Appendix A. Notice of Preparation and Scoping Comments

**REVISED PUBLIC NOTICE OF PREPARATION OF A
PROGRAM ENVIRONMENTAL IMPACT REPORT
AND
A SCOPING MEETING
PLANNING DEPARTMENT**

PROJECT NAME: De Anza Natural (Amendment to the Mission Bay Park Master Plan)

Subject: Notice of Preparation of a Program Environmental Impact Report for the De Anza Natural [Amendment to the Mission Bay Park Master Plan (SCH No. 22018061024)]

De Anza Natural
De Anza Cove Amendment to the Mission Bay Park Master Plan
Figure 3: Site Plan

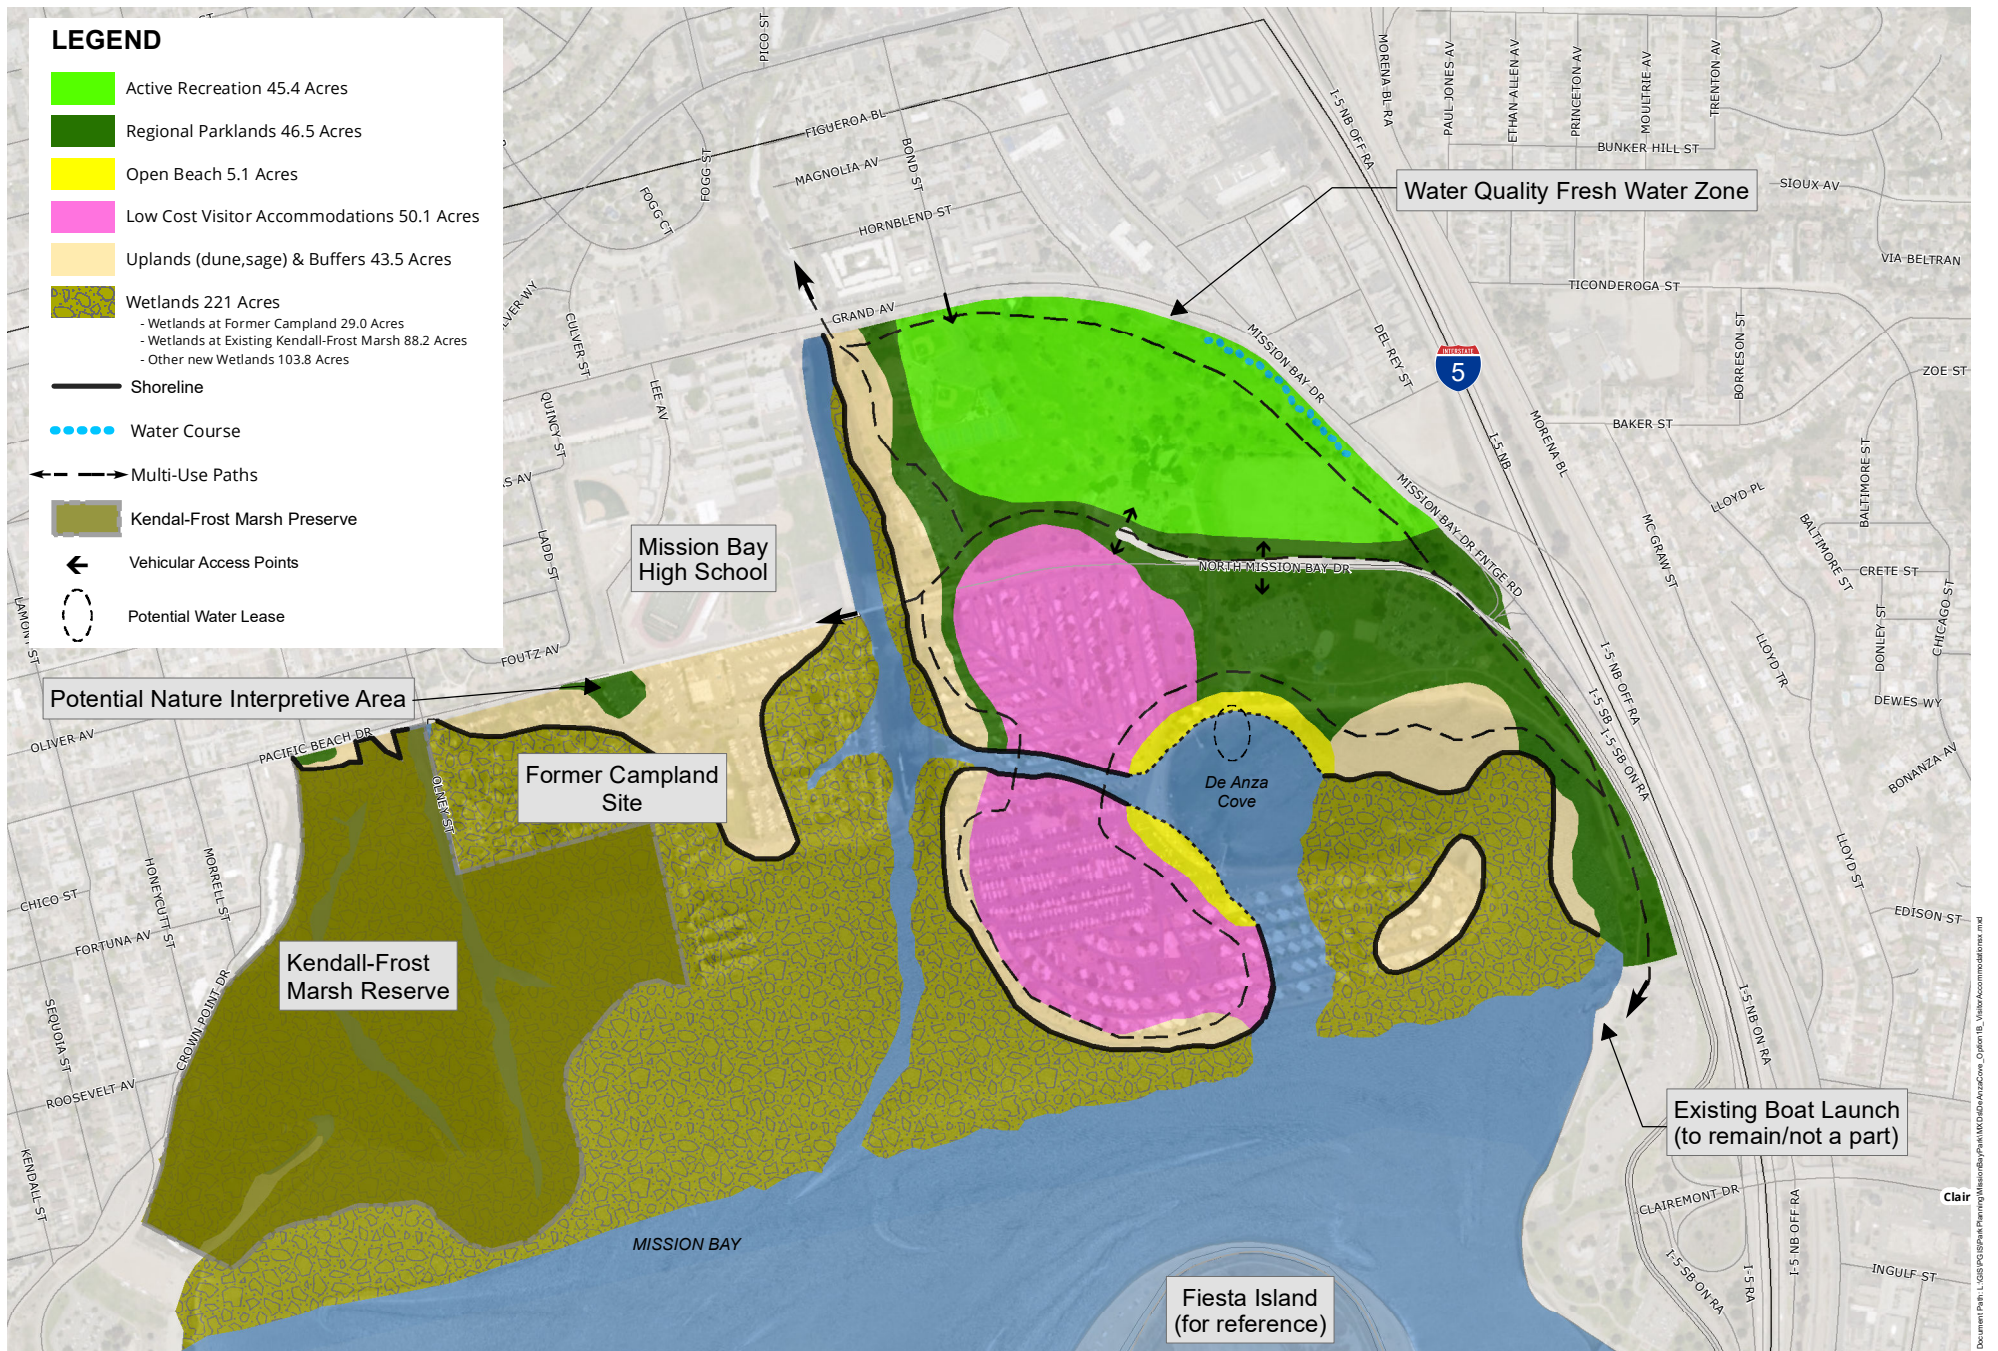
1. Figure 3 provided with the NOP lacks sufficient detail to determine the amount of the various wetland types (low-mid-high wetland/salt marsh and mudflats) and their associated acreage. The Draft PEIR should:
 - a. Clearly map the location and extent of upland transition zones.
 - b. Clearly map the various wetland types and their associated acreages and demonstrate how the proposed alternative would maximize implementable wetland restoration with the establishment of a minimum of 80 acres of additional functional wetlands at the Year 2100, based on current models utilized by the City for sea level rise projections.
2. The Draft PEIR should also discuss maintenance and adaptation measures considered or required for each of the alternatives proposed. In so doing, the PEIR should prioritize low maintenance alternatives that maximize habitat function (e.g. living shorelines).

6. The NOP (Figure 3) proposes a cut channel through the boot to De Anza Cove creating a southern island. The Draft PEIR should:
 - a. Provide a detailed hydrologic analysis to show whether the proposed channel will provide added flushing and water circulation benefits and will not negatively affect the Kendall Frost reserve or impact its beneficial uses.
